V P Subdivision

APPLICATION NUMBER 5 DATE January 7, 2016

DETAIL SITE PLAN

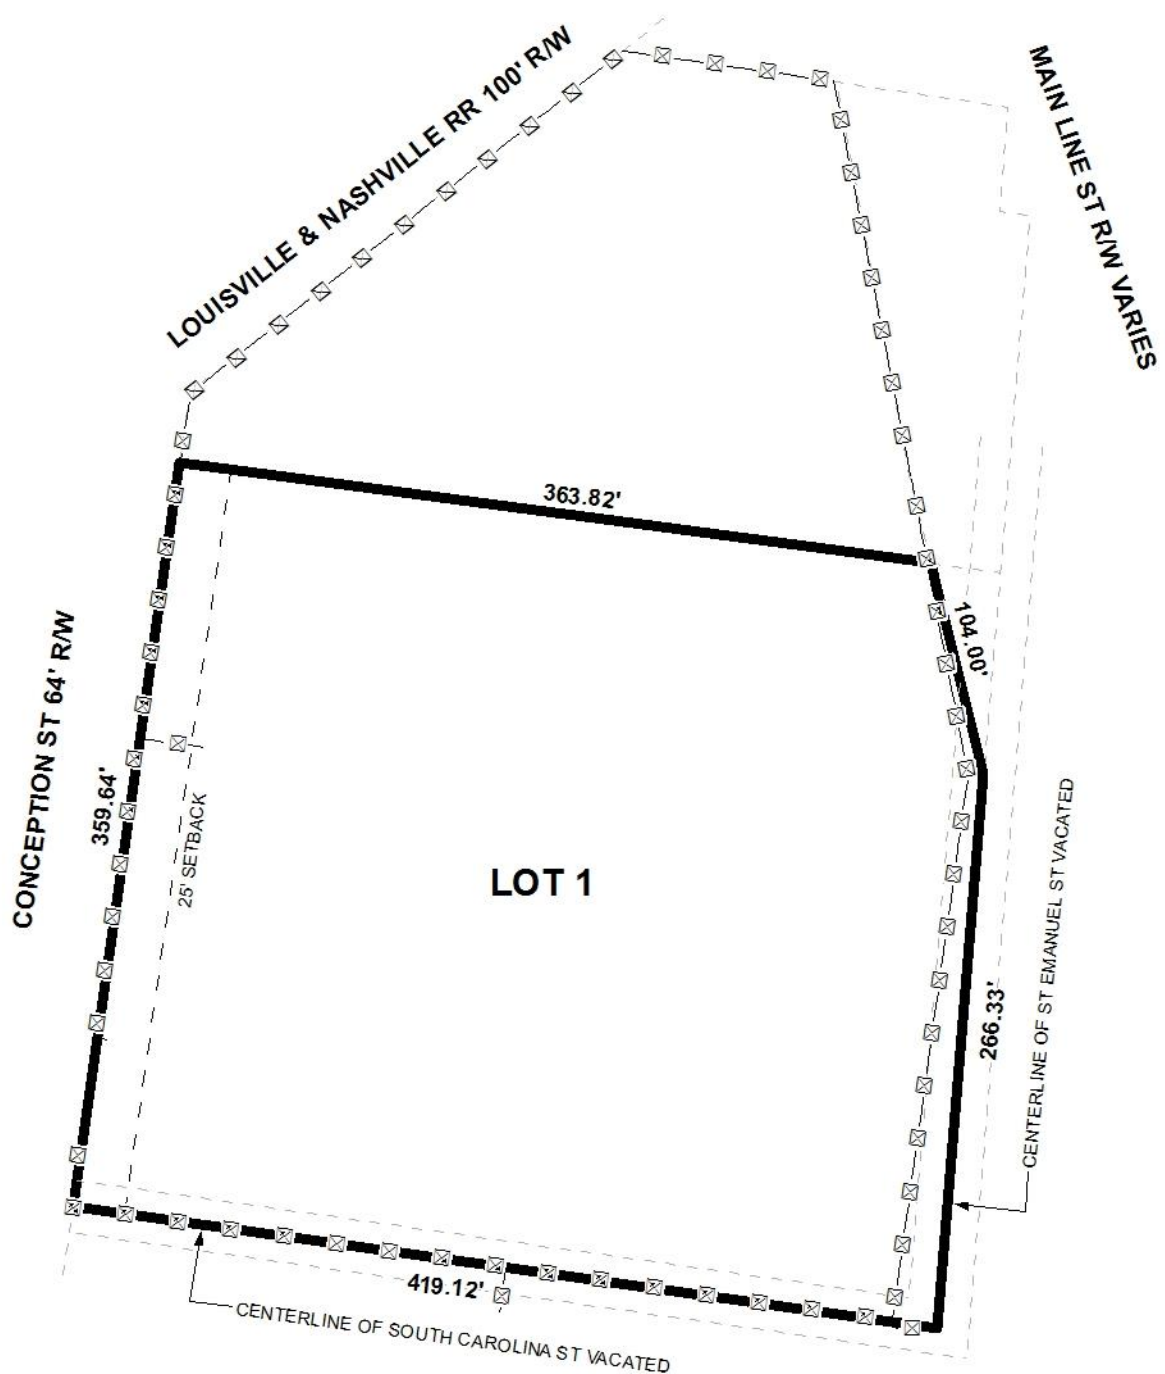
The proposed lot has frontage along South Conception Street, a minor street with curb and gutter. A compliant 64' right-of-way is depicted and, as such, no dedication is required.

The site should be limited to its existing two curb cuts, with any changes in their sizes, designs, and locations to be approved by Traffic Engineering and conform to AASHTO standards.

The proposed lot meets the minimum size requirements of the Subdivision Regulations and is illustrated on the preliminary plat in square feet and acres; if approved, this information should be retained on the Final Plat, or a table should be furnished on the Final Plat providing the same information.

The 25' minimum building setback line is shown on the preliminary plat and should be retained on the Final Plat, if approved.

It should be noted that the existing site is developed with multiple buildings and has cross access with an adjacent parcel; as such, application for a Planned Unit Development and an additional lot should be approved by the Planning Commission.

Based on the preceding this application is recommended for Holdover to the February 18th meeting, with revisions or additional information to be submitted by January 19th:

- 1) revision of the Subdivision application to include the adjacent parcel to which the site has access; and
- 2) submission of a Planned Unit Development application to the Planning and Zoning Department to allow shared access between lots and to allow multiple buildings on a single building site.
